Product Service Group CE Audio

Service Information

CORRECTION TO SERVICE MANUAL

CHANGES DURING PRODUCTION

FRONT DISPLAY BOARD

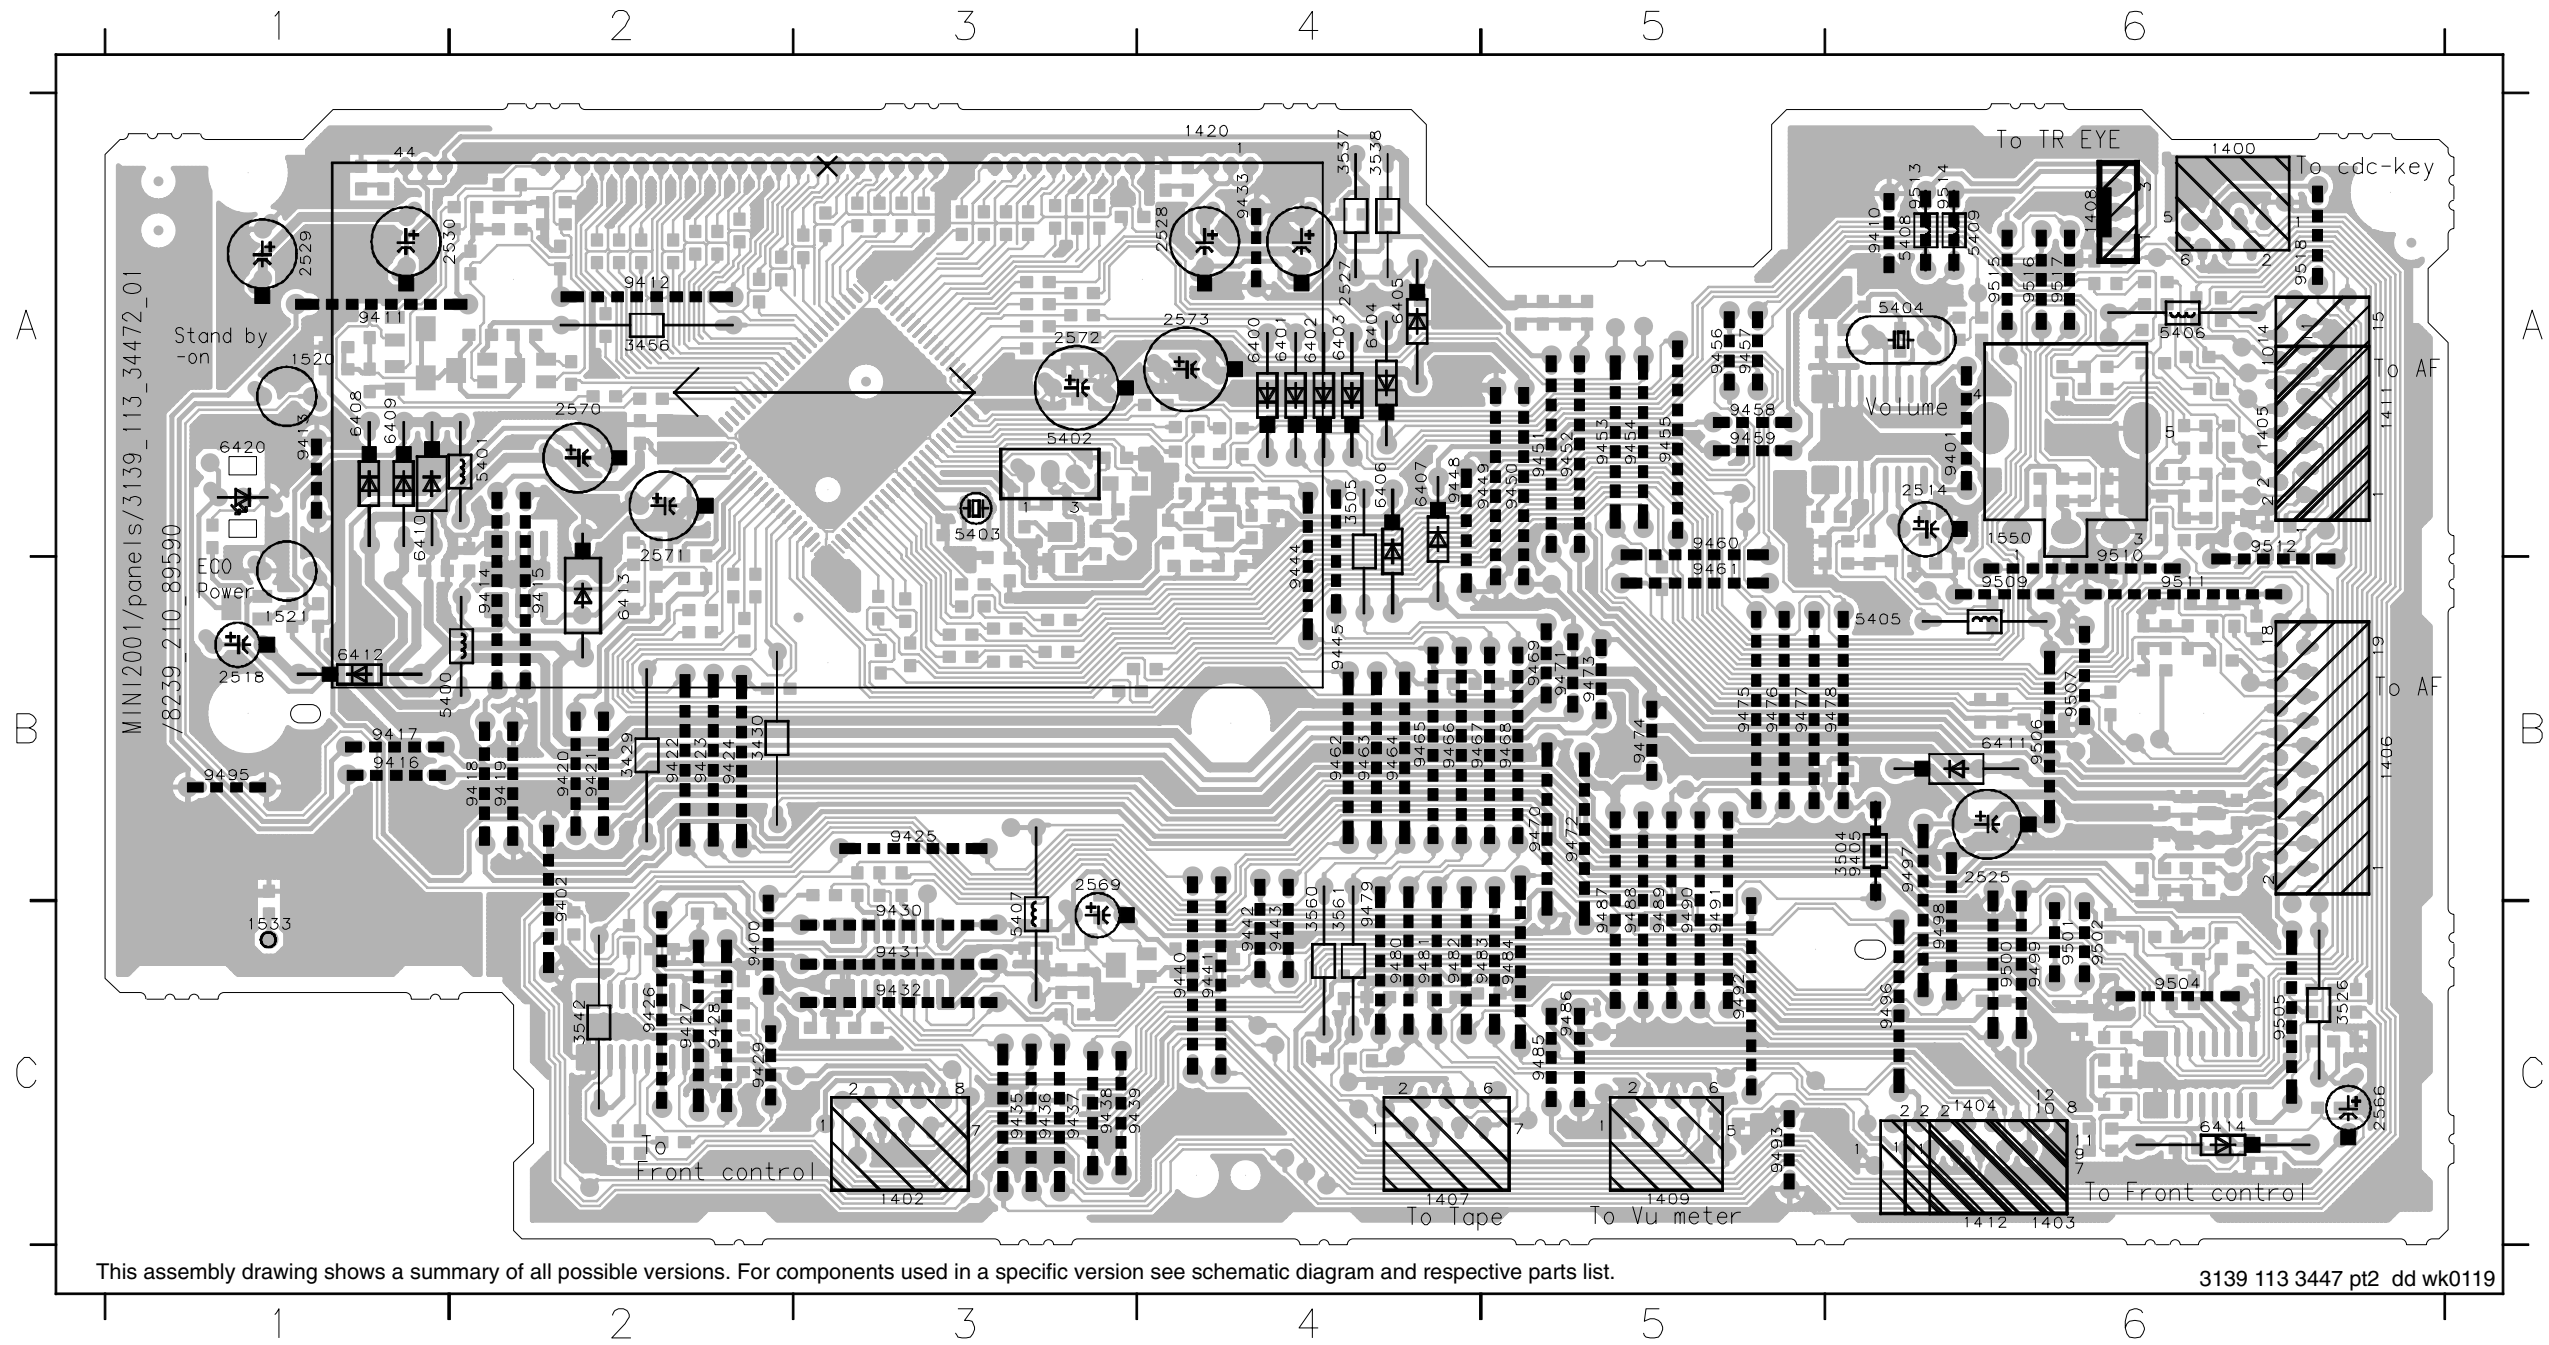
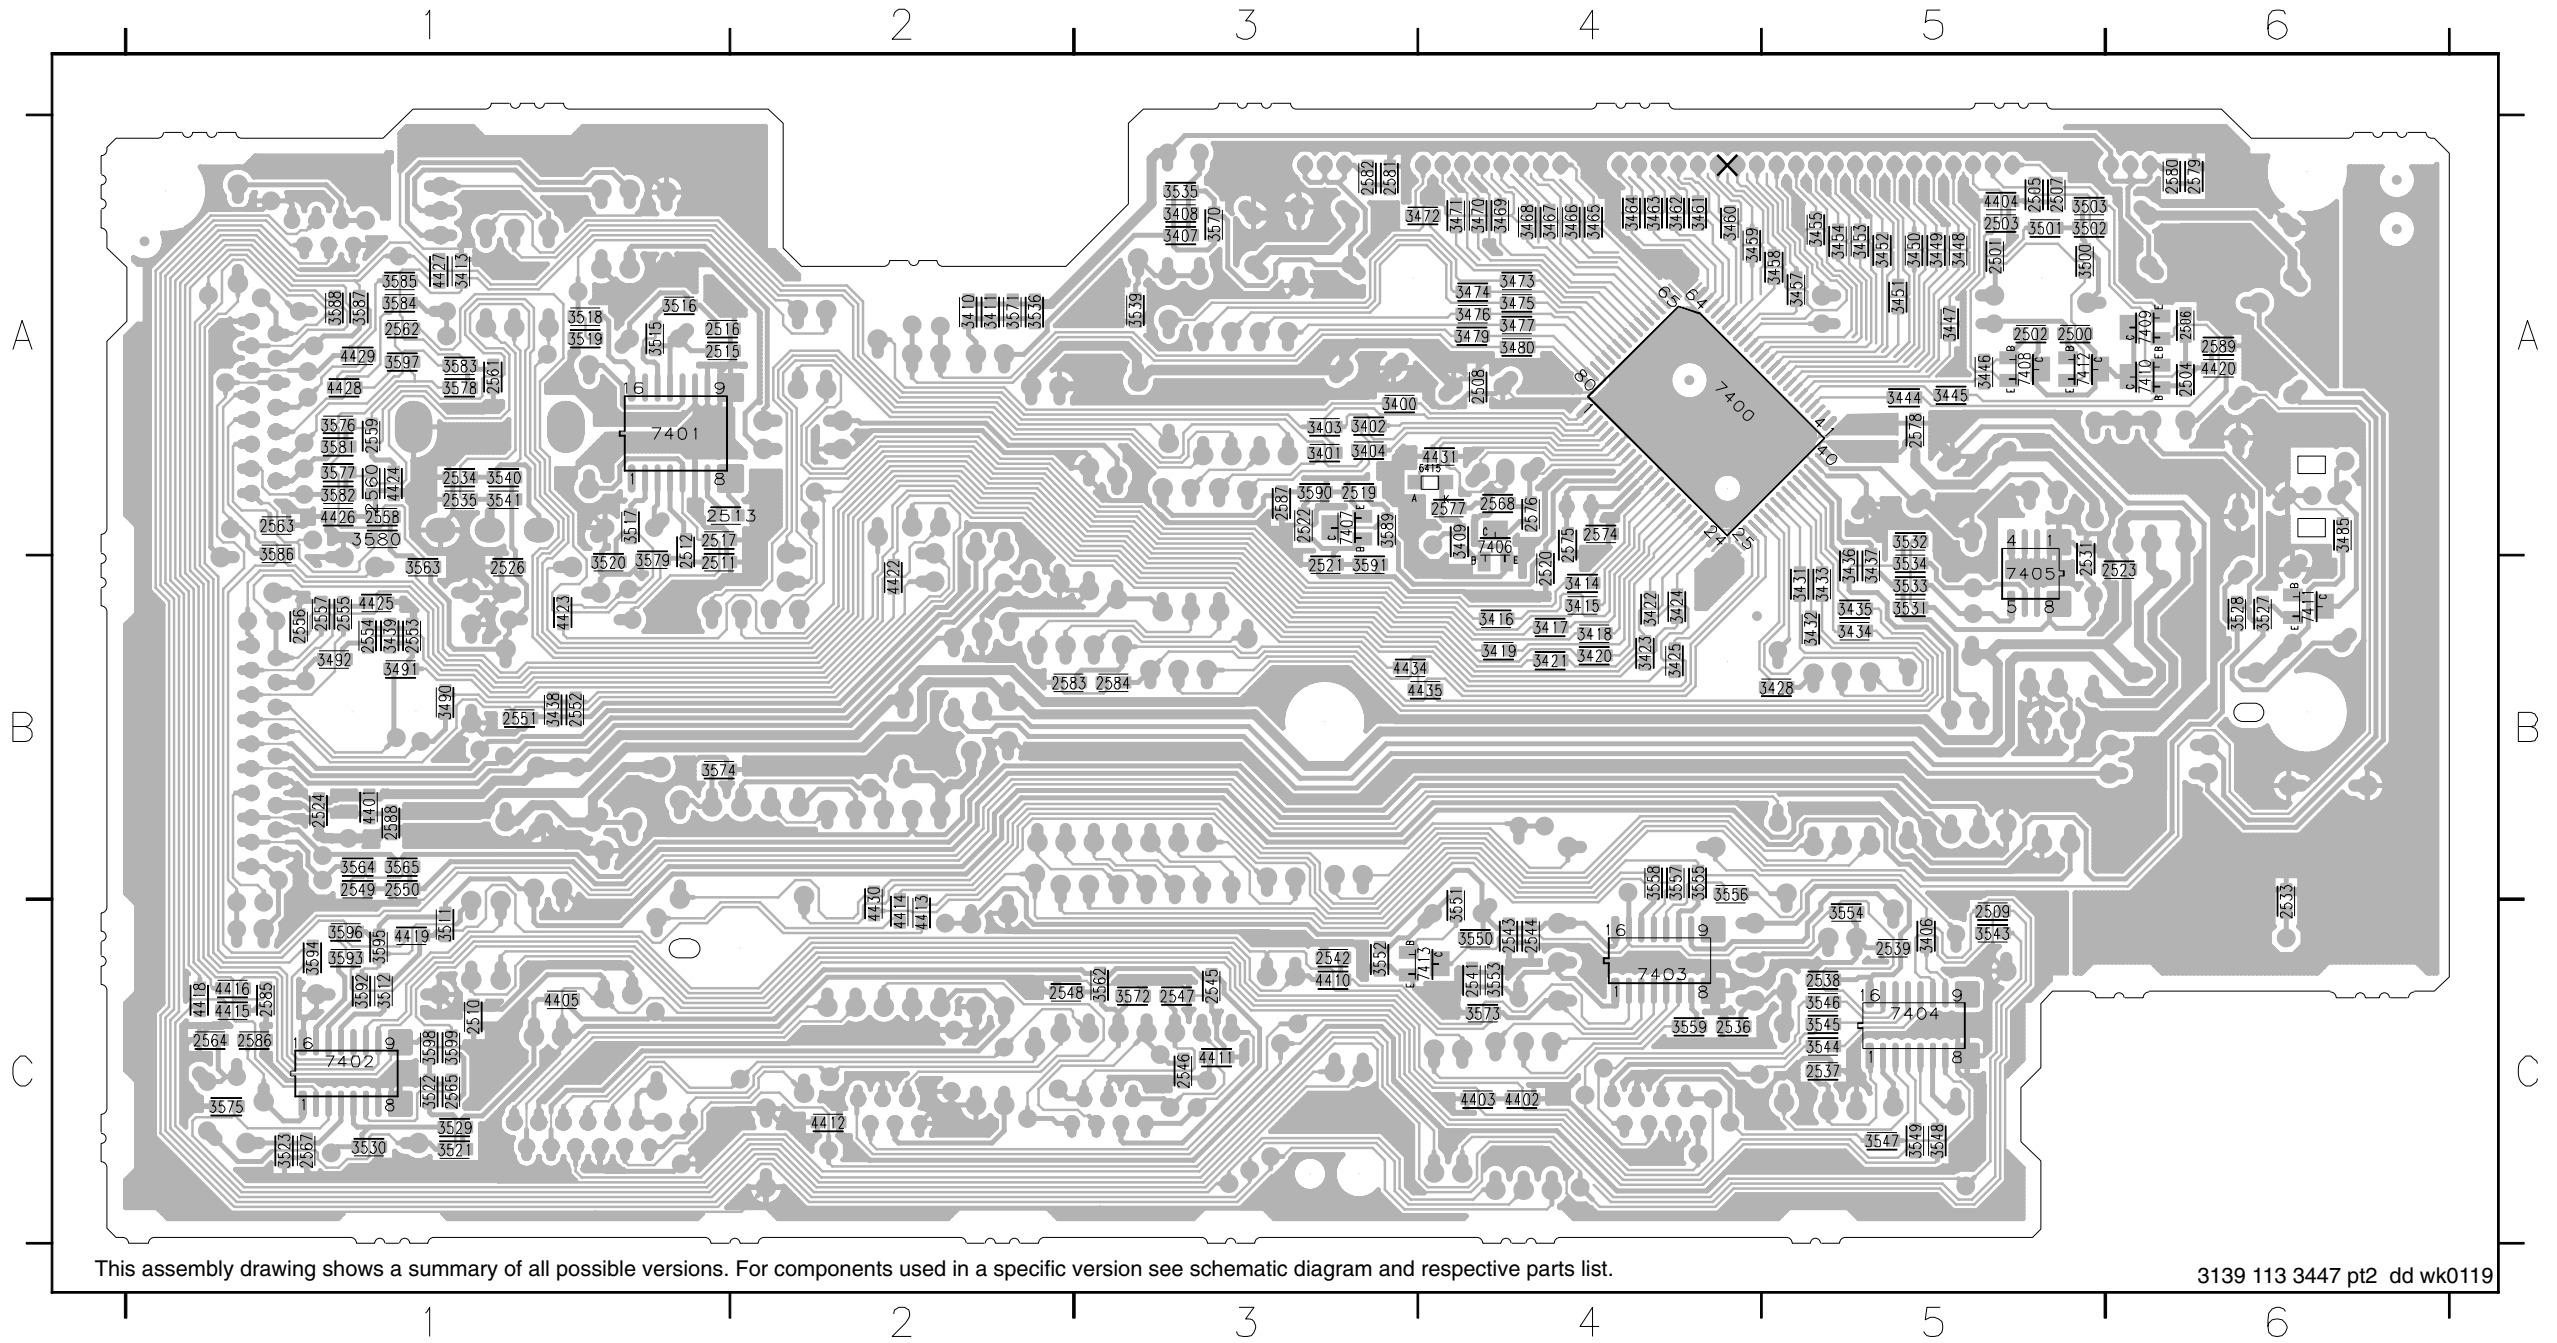
*From production week 0110 onwards pt.2 Board (identified by the last digit of the 12NC - 3139 113 34472) is introduced. For this reason new layout and circuit drawing are enclosed.

Reason : Solution for tuner-locking issue.

Add 6415 4822 130 11397 BAS316
Change 3409 4822 117 12925 47k 1% 0,063W
Delete 3405

Reason : ESD solution.

Add 2585 4822 126 13883 220pF 5% 50V
2586 4822 126 13883 220pF 5% 50V
2587 3198 017 41050 1uF 10V
2588 4822 126 13879 220nF +80/-20% 16V
2589 3198 017 41050 1uF 10V
5408 4822 157 62552 Coil 2,2uH 5%
5409 4822 157 62552 Coil 2,2uH 5%
Change 2563 5322 126 11583 10nF 10% 50V
Delete 9513, 9514 Bare wires
